**Proposal #07: 5944-03-83**  
**Darlington - Argyle**  
**Clay Street to Arthur Street**  
**STH 81**  
**Lafayette County**

This is Addendum No.01, which provides for the following:

**ADDENDUM NO. 01**

Addendum No. 01  
ID 5944-03-83  
Revised Sheet 10  
February 9, 2017

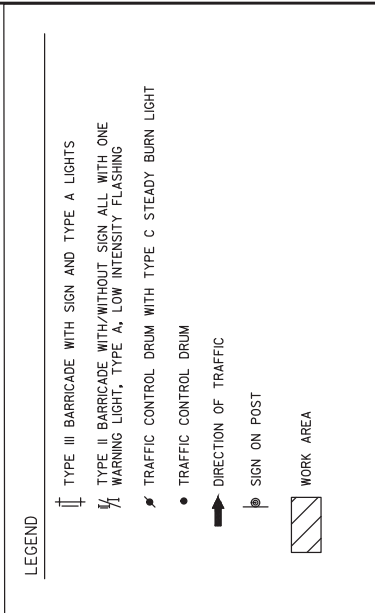
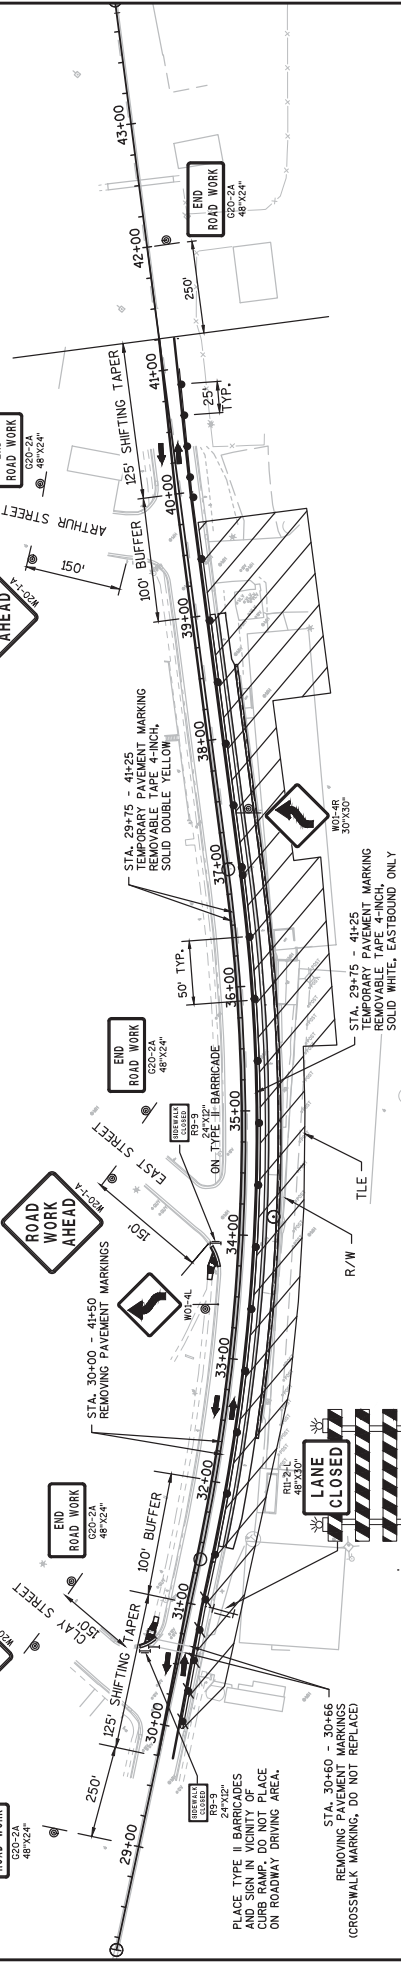
Revised Plan Sheets	
Plan Sheet	Plan Sheet Title (brief description of changes to sheet)
10	Revised the minimum lane width of traffic through the work zone from 12' to 11'.
